STATE OF NORTH CAROLINA
DEPARTMENT OF TRANSPORTATION

September 2, 2011

Subject: Permit Modification Request for Section 404 Nationwide Permit 23 and Section 401 Water Quality Certification for the proposed construction of the Neuse River Greenway from Wake/Johnston County Line to Sam's Branch Creek in Johnston County, TIP EB-4993. Debit \$240.00 from WBS 40892.1.1

Permit Drawing
Sheet 10 of 36
revised 7/18/11

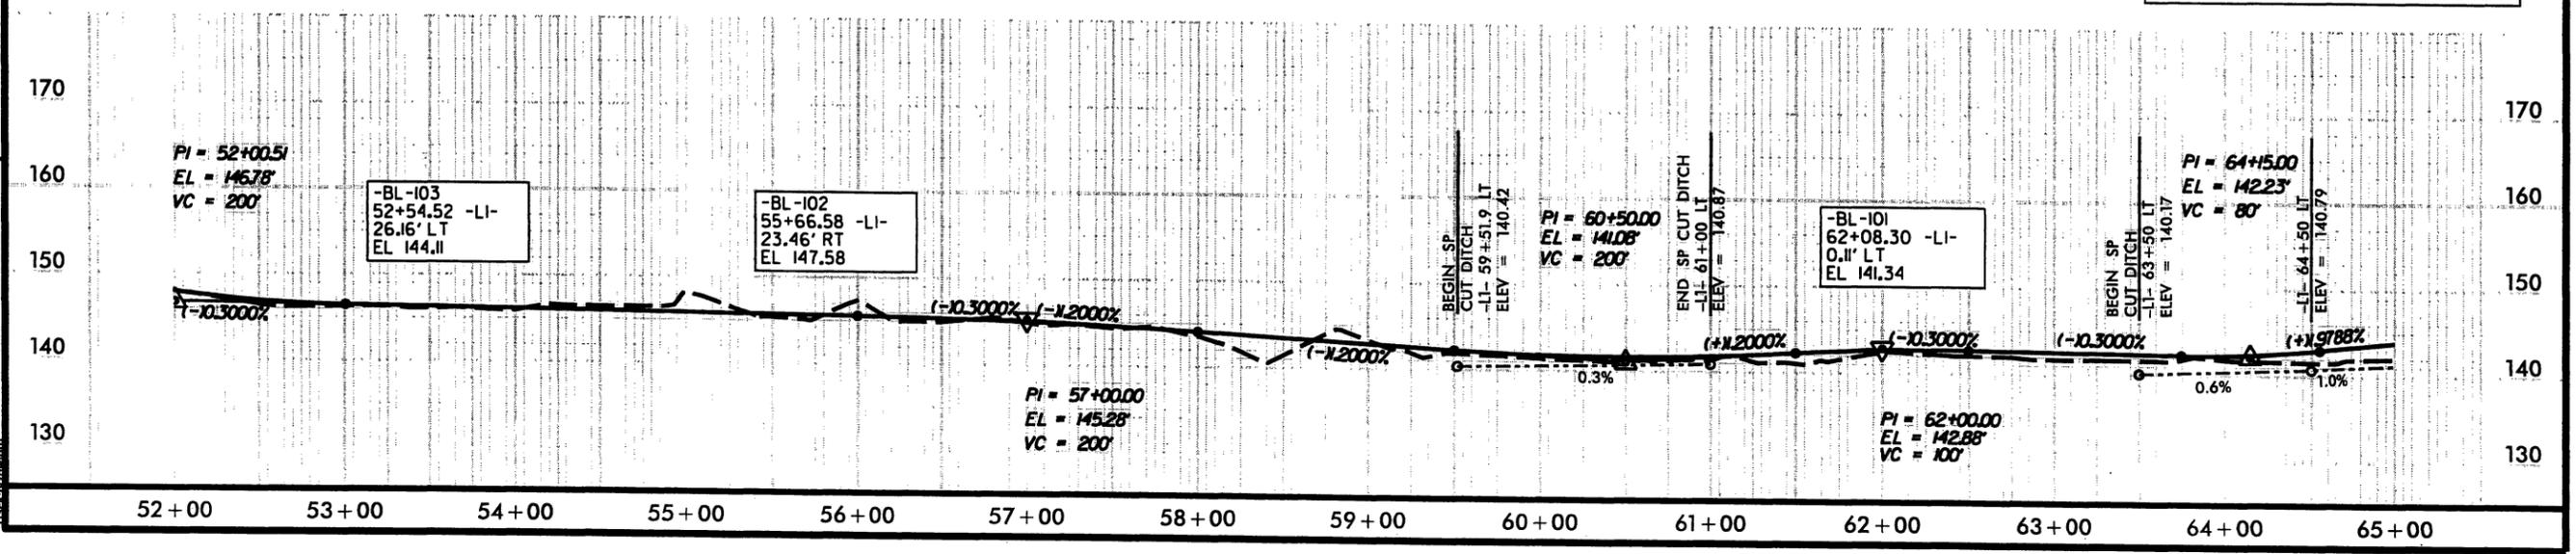
Please see the enclosed revised permit drawings, roadway plan sheet, and revised EEP Acceptance Letter dated July 25, 2011 for the above referenced project. The original wetland boundary provided by NCDOT at Site 5 has been modified since the above referenced permits were issued. The wetland was originally shown to be outside of the slope stakes of the trail and would only require hand clearing for this project. During a field visit, it was determined that the wetland was actually located within the slope stakes of the trail. The wetland has been re-surveyed and has resulted in impacts at Site 5 which now include 0.01 acre of wetland fill. This additional 0.01 acre of wetland fill increases the total permanent wetland impacts on this project to 0.17 acre. Permanent stream impacts will remain unchanged.

REVISIONS
AUGUST 17, 2011 - WETLAND BOUNDARY AT STA. 55+00 UPDATED
